Access Compliance Report

Public Rights-of-Way

Intersection ID: 29278	Main Street: OLD_VINE_CT	Cross Street: PAWLEY_DR	Location: NW
ADA ID: 12BBB4BF83F6	Ramp Type: PerpDiag	Initial Pass/Fail: Fail	Overall Compliance: No
		Severity Score: 8.75

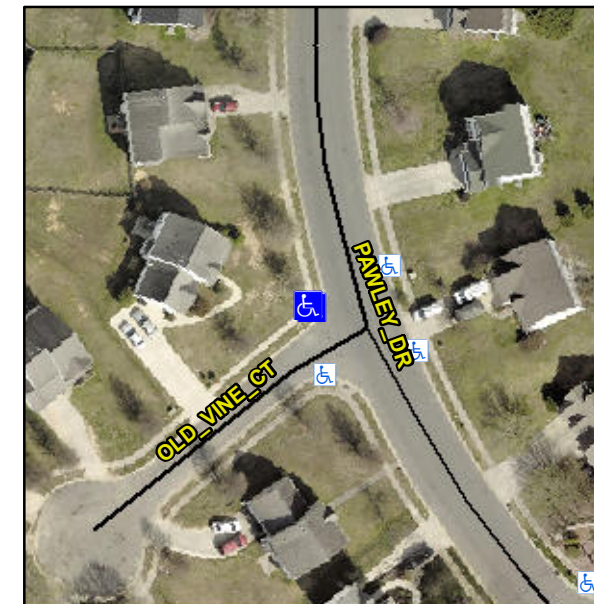
Not Found, R304.5.1

Compliance	Description	Data	Compliance	Description	Data
N/A	Ramp Length (in)	43.0	Yes	Ramp Slope (%)	5.1
No	Ramp Width (in)	47.5	Yes	Ramp XSlope (%)	1.8
N/A	Flare Type LT	N/A	N/A	Flare Type RT	N/A
N/A	Flare Slope LT (%)	N/A	N/A	Flare Slope RT (%)	N/A
N/A	Flare Traversable LT?	N/A	N/A	Flare Traversable RT?	N/A
N/A	Landing Length (in)	N/A	N/A	DWS Provided?	N/A
N/A	Landing Width (in)	N/A	N/A	DWS Contrast?	N/A
N/A	Landing Slope (%)	N/A	N/A	DWS Length (in)	N/A
N/A	Landing X Slope (%)	N/A	N/A	DWS Full Width?	N/A
N/A	Landing Curb? (Y/N)	N/A	N/A	DWS Offset (in)	N/A
N/A	Shared Landing?	N/A			
N/A	Gutter Ponding?	N/A	N/A	Gutter Slope (%)	N/A
N/A	Gutter Lip Ht (in)	N/A	N/A	Gutter X Slope (%)	N/A
N/A	Painted X Walk1?	No	N/A	Painted X Walk2?	No
	X Walk 1 Direction	To S		X Walk 2 Direction	To E
N/A	X Walk 1 Width (in)	N/A	N/A	X Walk 2 Width (in)	N/A
	X Walk 1 Slope (%)	0.1		X Walk 2 Slope (%)	3.5
	X Walk 1 X Slope (%)	3.1		X Walk 2 X Slope (%)	1.3

Remove & Replace Curb Ramp With Two New Directional Ramps or Equivalent.
